Nepal Electricity Authority
Project Management Directorate
Khimti-Barhabise-Lapsipedi 400 kV Substation Project

OCB No.: PMD/PTDSSP/KBL-75/76-01" Design, Supply, Installation and Commissioning of 400 kV Gas Insulated Substations (GIS) at New Khimti, Barhabise and Lapsipedi"

Clarification No. 1					
S.N.	Vol/Sec	Clause	Text as per Bid document	Bidder's Queries	NEA Response
1	Vol-I, Section-1	ITB 35.2 and BDS	ITB -The determination shall be based upon an examination of the documentary evidence of the Bidder's qualifications submitted by the Bidder, pursuant to ITB 15. Unless permitted in the BDS, the determination shall not take into consideration the qualifications of other firms such as the Bidder's subsidiaries, parent entities, affiliates, subcontractors (other than Specialist Subcontractors if permitted in the bidding document), or any other firm(s) different from the Bidder. BDS- The qualifications of other firms such as the Bidder's subsidiaries, parent entities, affiliates, subcontractors shall not be permitted.	In case of the carve out ,merger, demerger of companies and a new entity formed due to the same, can you please clarify as to what financial and technical qualifica

REV	DATE	MODIFICATION
NEPAL ELECTRICITY AUTHORITY 400 KV GIS NEW NEW KHIMTI SUBSTATION SINGLE LINE DIAGRAM		
DRAWING No.		KHIMTI-GIS-GLD-1

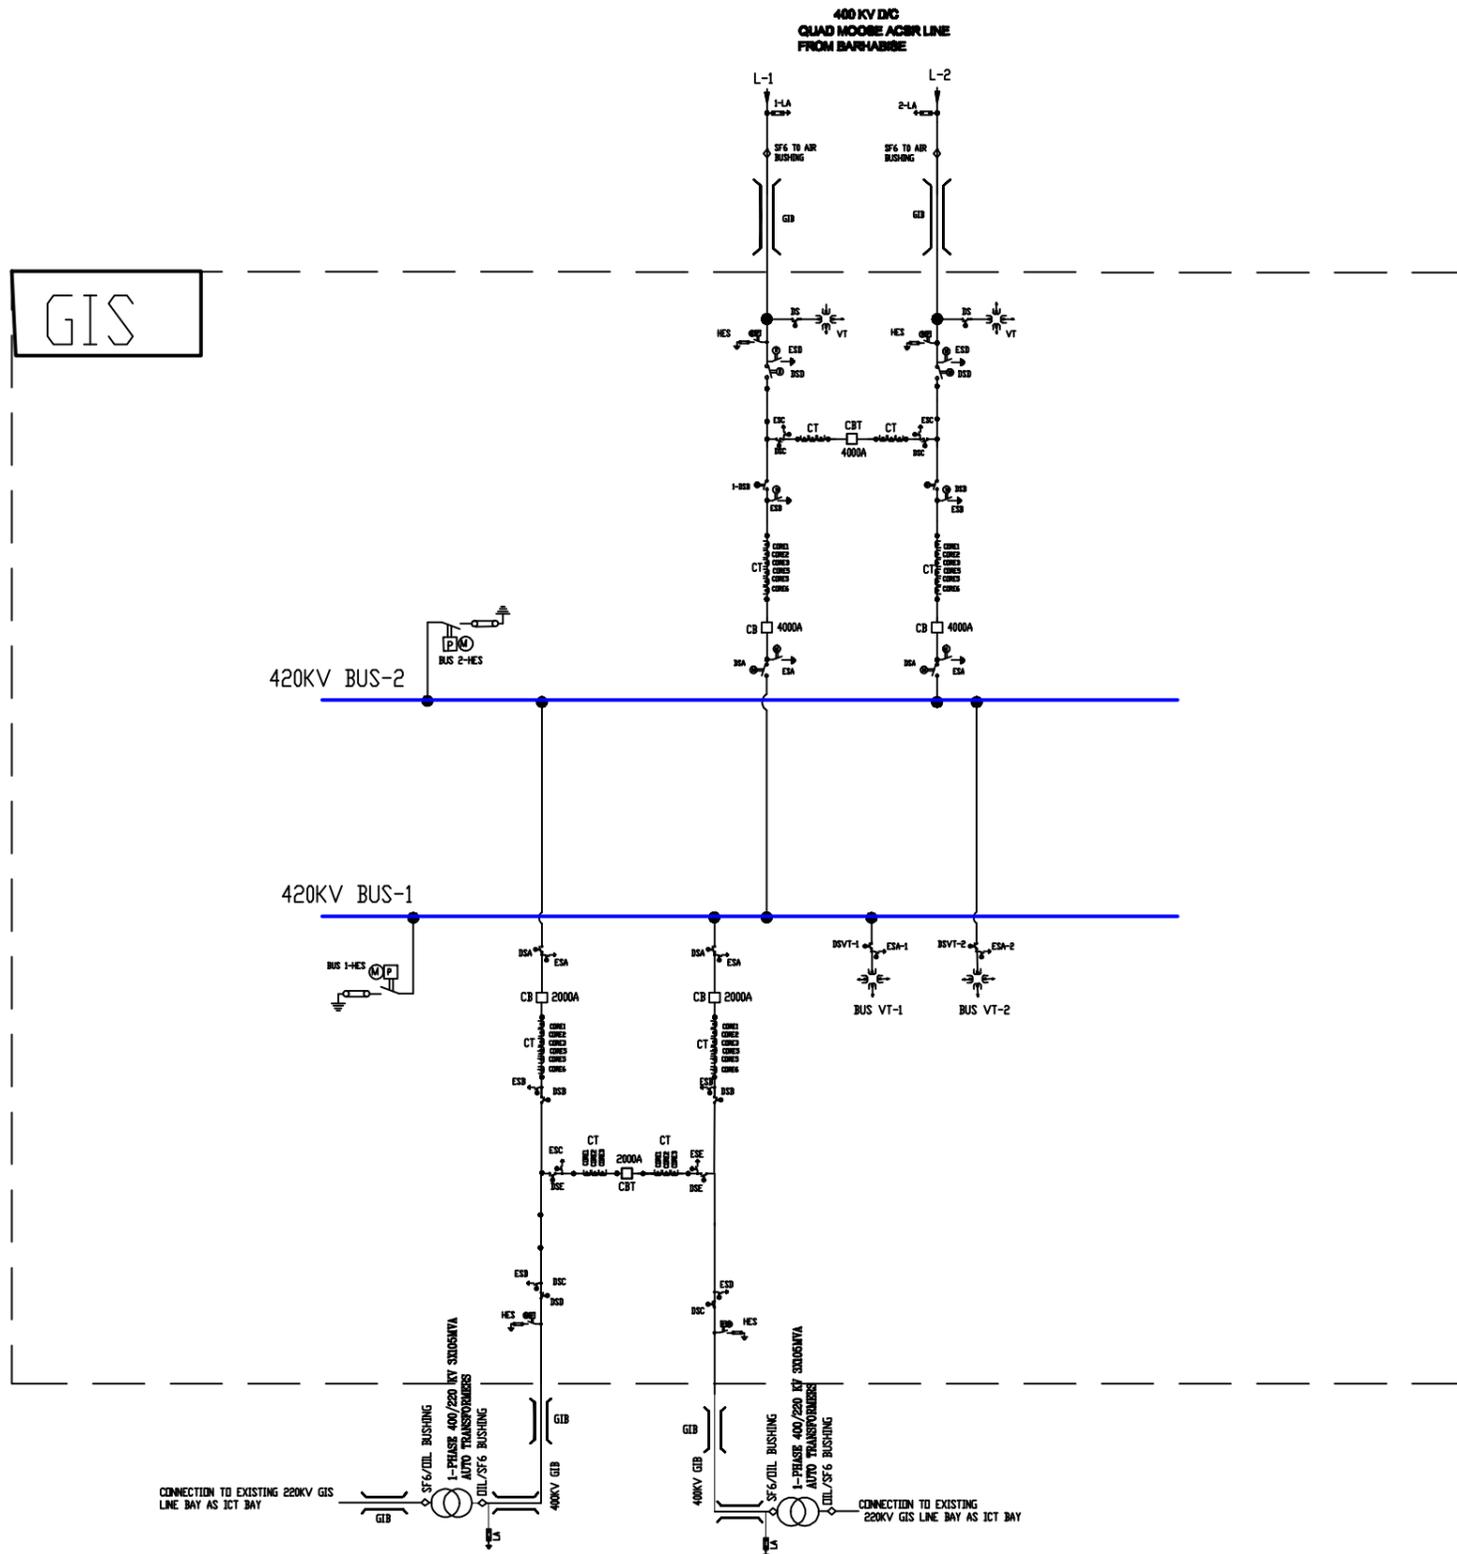
33	New Khimti	Single Line Diagram & Price Schedule - New Khimti Substation	sl no I, 1.1, a)	400kV CB relay panel with Auto-recloser- 2 sets	As per the SLD, the quantity of 400kV CB relay panels with Auto-recloser shall be 3 sets at New Khimti SS including associated tie bays. Please check & revise the BPS.	Bidder is to quote as per BPS
34	New Khimti	Single Line Diagram & Price Schedule - New Khimti Substation	sl no I, 1.3	Transformer protection panel (for HV & LV)- 1 set	As per SLD Transformer protection panel (for HV & LV) qty shall be 2 sets at New Khimti SS. Please check & revise the BPS.	Bidder is to quote as per BPS
35	New Khimti	Price Schedule - New Khimti Substation	sl no I, 1.4, b) sl no J, 1.5, b) sl no I, 1.4, b)	Augmentation of existing 220 kV bus bar protection scheme - 1 Lot	We understand that the complete bus bar protection for 220kV GIS which is under construction is covered other package at New Khimti. Hence 220kV bus bar protection augmentation is not applicable in bidder scope, since 220kV bays to be used for our Transformer LV termination are also covered in other package. Kindly confirm.	Augmentation of existing 220 kV bus bar protection scheme for 220 kV ICT bays is under present scope of works

400 KV GIS NEW BARHABISE SUBSTATION
SINGLE LINE DIAGRAM

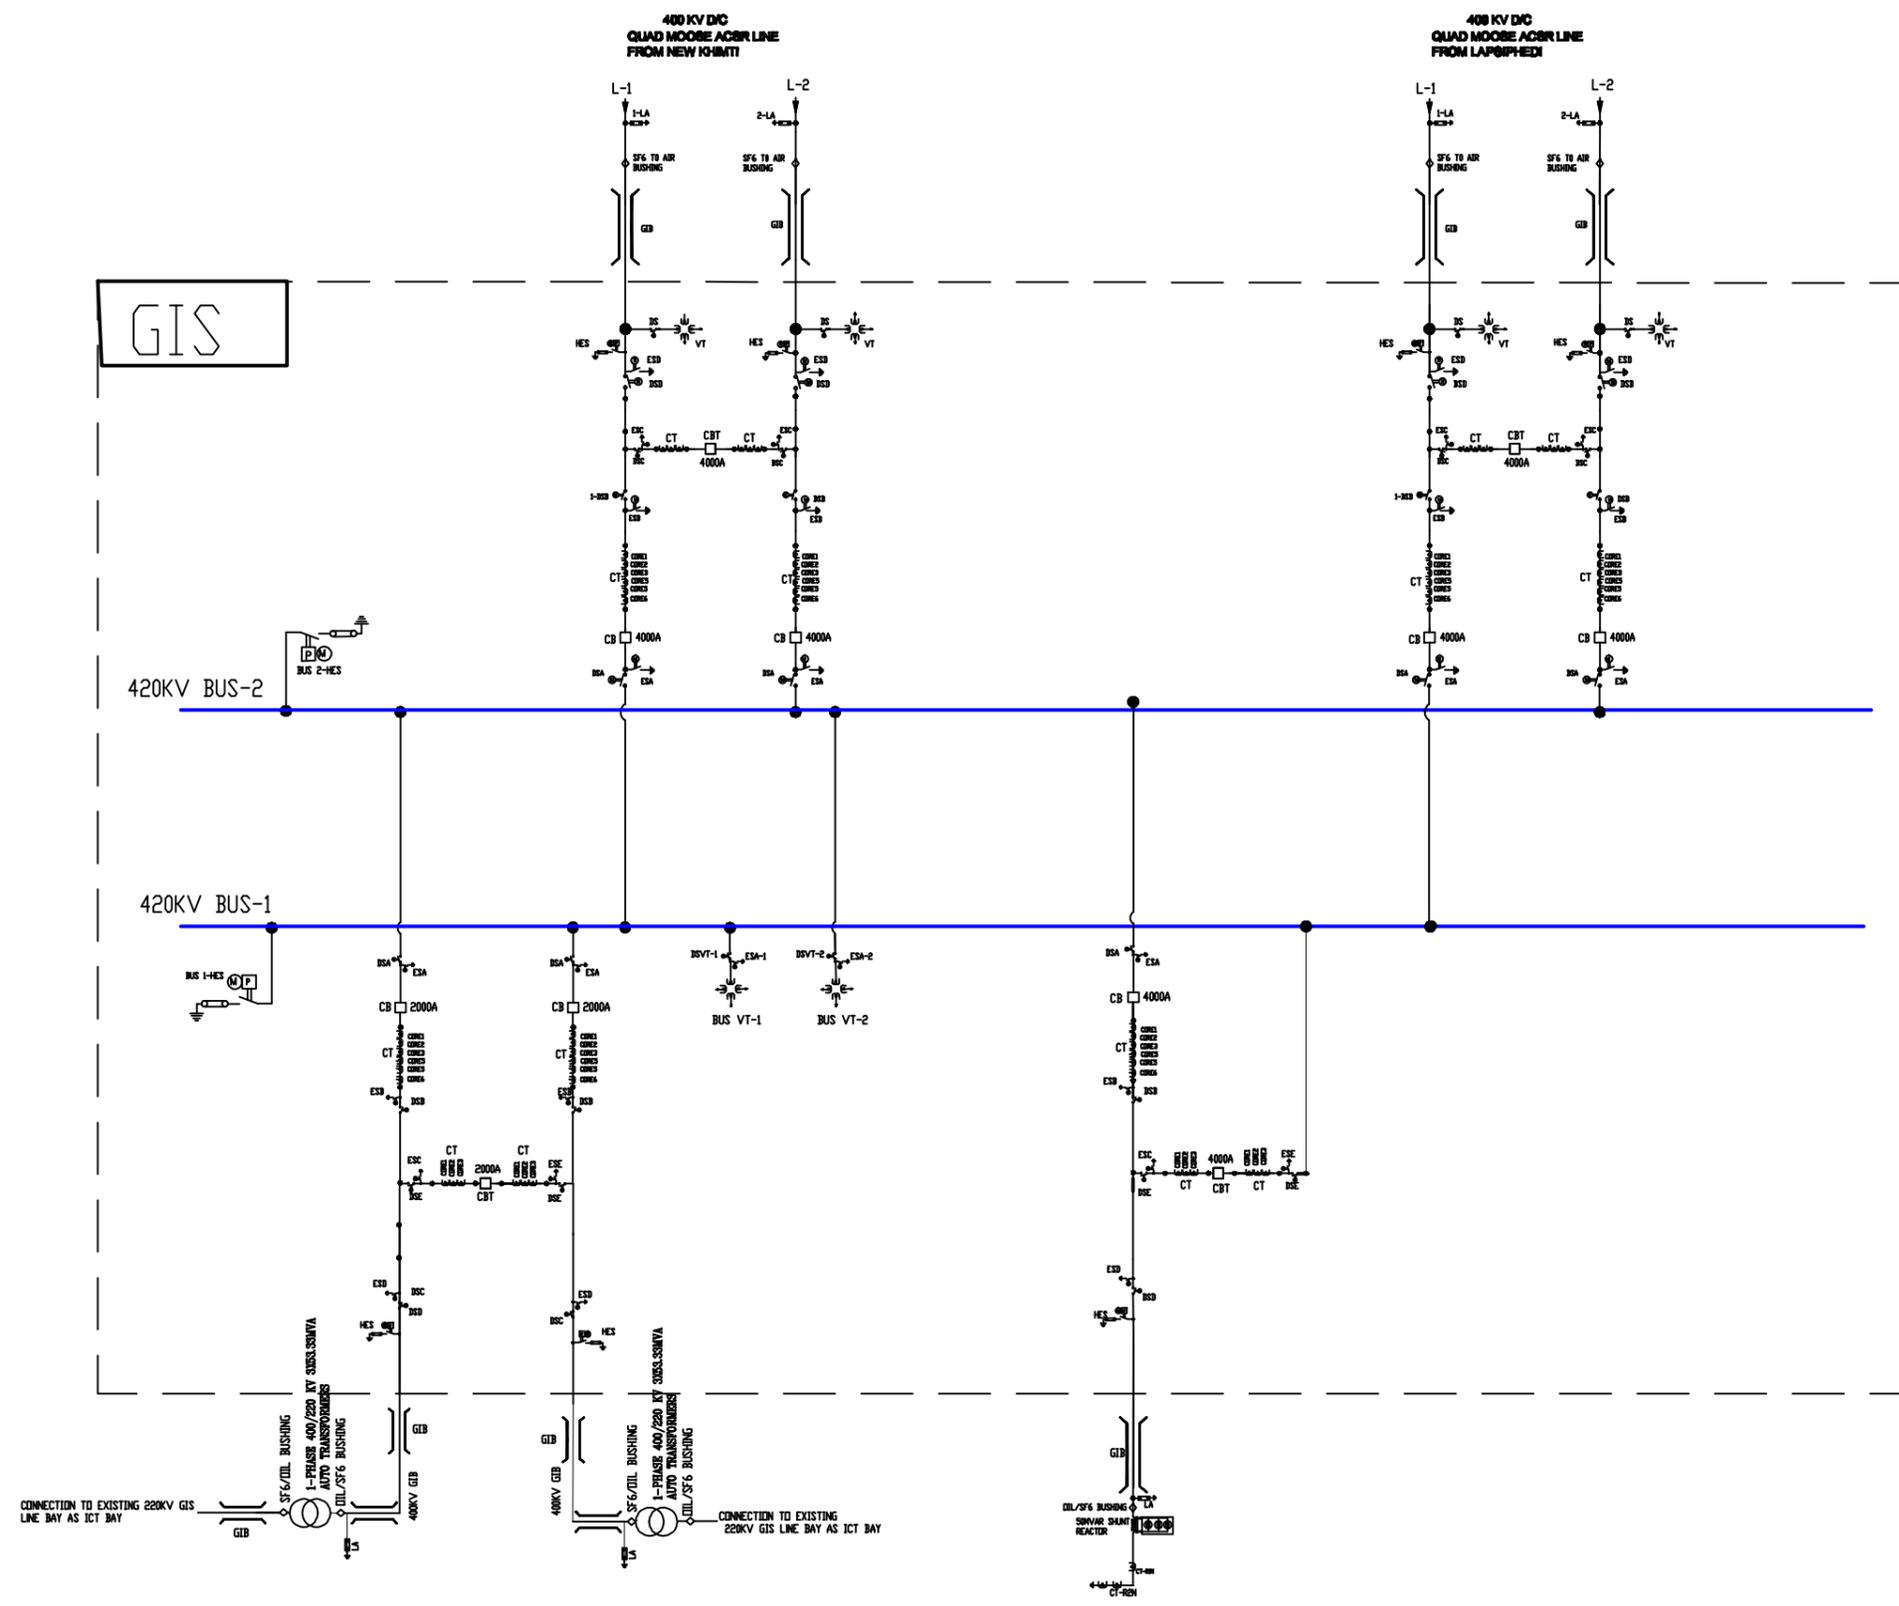
40	Barhabise	Single Line Diagram & Price Schedule - New Barhabise Substation	sl no J, 1.1, b)	400kV CB relay panel with out Auto-recloser- 6 sets	As per SLD 400kV CB relay panels with out Auto-recloser qty shall be 5 sets at New Barhabise SS. Please check & revise the BPS.	Bidder is to quote as per BPS
41	Barhabise	Single Line Diagram & Price Schedule - New Barhabise Substation	sl no J, 1.3	Transformer protection panel (for HV & LV)- 1 set	As per SLD Transformer protection panel (for HV & LV) qty shall be 2 sets at New Barhabise SS. Please check & revise the BPS.	Bidder is to quote as per BPS
42	Barhabise	1558513179_Vol II(Part 1 of 2)_KBL	Chapter 1. Project Specific Requirement. nt. Cl 1.5.2	The Bidder shall install Giga-Ethernet cards compatible with existing SDH Equipment installed at Barhabise Substation.	Please confirm the make & model of the existing SDH equipment at Barhabise substation.	Existing SDH equipment is Siemens make

NEPAL ELECTRICITY AUTHORITY
400 KV GIS NEW LAPSIPHEDI SUBSTATION
SINGLE LINE DIAGRAM

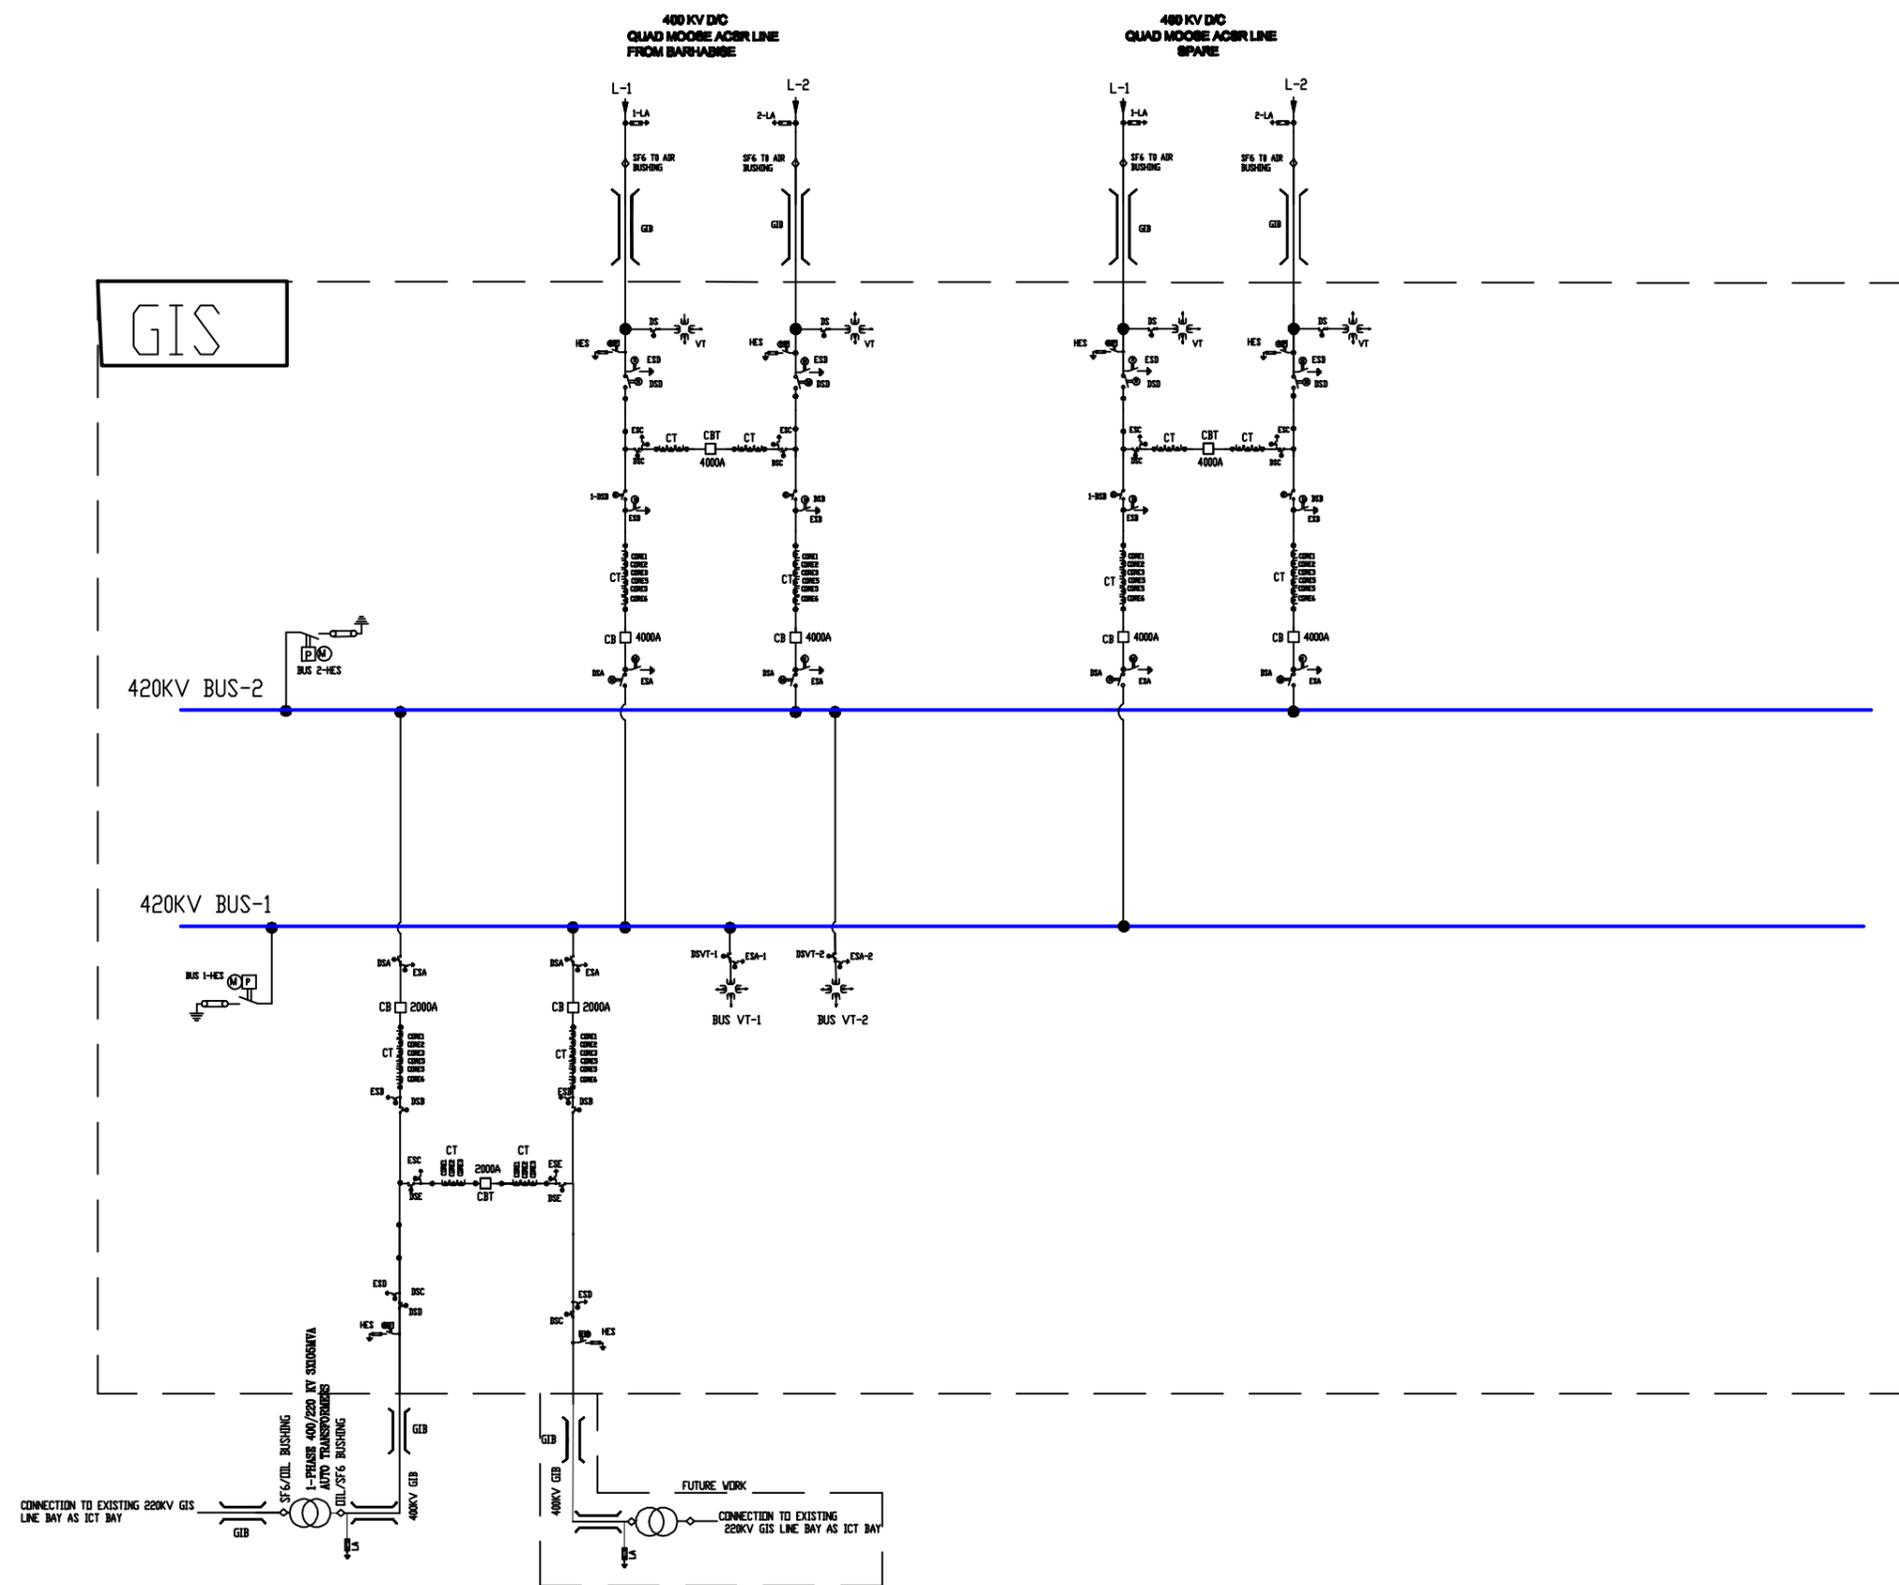
43	Lapsiphedi	Single Line Diagram & Price Schedule - Lapsiphedi	sl no I, 1.1, a)	400kV CB relay panel with Auto-recloser- 4 sets	As per SLD 400kV CB relay panels with Auto-recloser qty shall be 6 sets at Lapsiphedi SS including associated tie bays also. Please check & revise the BPS.	Bidder is to quote as per BPS
44	Lapsiphedi	Single Line Diagram & Price Schedule - Lapsiphedi	sl no I, 1.1, b)	400kV CB relay panel with out Auto-recloser- 4 sets	As per SLD 400kV CB relay panels with out Auto-recloser qty shall be 3 sets at Lapsiphedi SS. Please check & revise the BPS.	Bidder is to quote as per BPS
45	Lapsiphedi	Single Line Diagram & Price Schedule - Lapsiphedi	sl no I, 1.3	Transformer protection panel (for HV & LV)- 1 set	As per SLD Transformer protection panel (for HV & LV) qty shall be 2 sets at Lapsiphedi SS. Please check & revise the BPS.	Bidder is to quote as per BPS
46	Lapsiphedi	1558513179_Vol II(Part 1 of 2)_KBL	Chapter 1. Project Specific Requirement. nt. Cl 1.5.3	The Bidder shall install Giga-Ethernet cards compatible with existing SDH Equipment installed at Lapsiphedi Substation.	Please confirm the make & model of the existing SDH equipment at Lapsiphedi.	shall be provided during detail engineering

DRAWING NO. NEW KHIMTI - GIS - LAYOUT - 02(A)

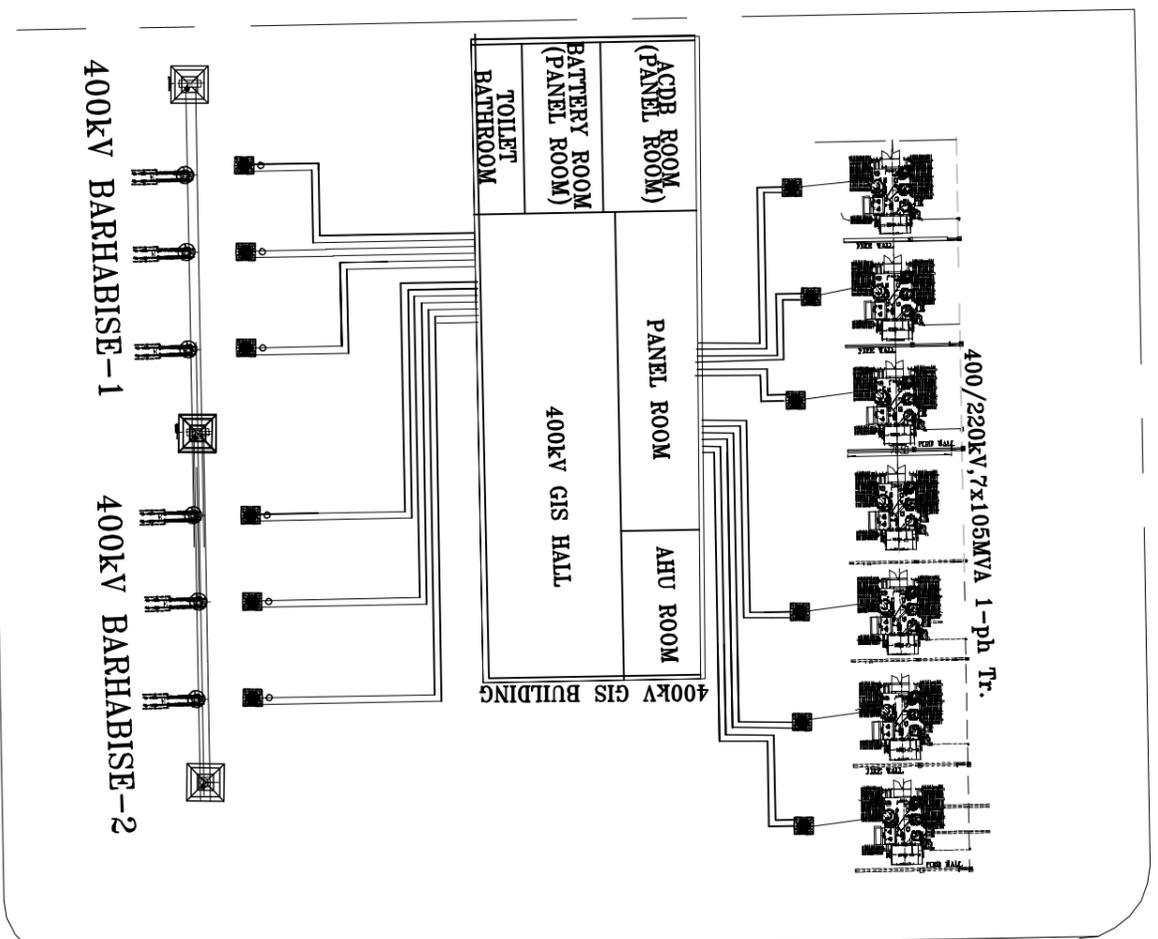
27	New Khimti Substation	Drawings and Bid Price Schedule	Electrical Layout plan of New Khimti Substation		It is observed that the 220kV Incomer side is exactly opposite of 400kV Switchyard. It is also shown that 220kV Cable are terminated into the 220kV GIS in line bay which will be replaced by ICT bay under present scope of work. However, in BPS item no. B.a(1), 360m of single phase 220kV Gas Insulated Bus duct has been specified. Also, in BPS item no. B.b(1), 6 nos. SF6 to Air bushing is indicated. Kindly clarify in which portion between 400/220kV ICT and 220kV ICT GIS bays the gas insulated bus duct will be used. During our site visit, it appeared that it will be easier to connect between 400/220kV Transformer LV side and existing 220kV GIS by cables. Hence, please clarify the requirement of 220kV Bus duct as well as SF6 to air bushing for Connecting GIS to AIS.	Layouts provided in bid document are tentative only. Layout arrangement can be changed considering technical requirements during detail engineering. Regarding choice of Cable and Bus duct for 220kV Connection, Please refer Vol II, Chapter-1 PSR S.N. 26 page-38
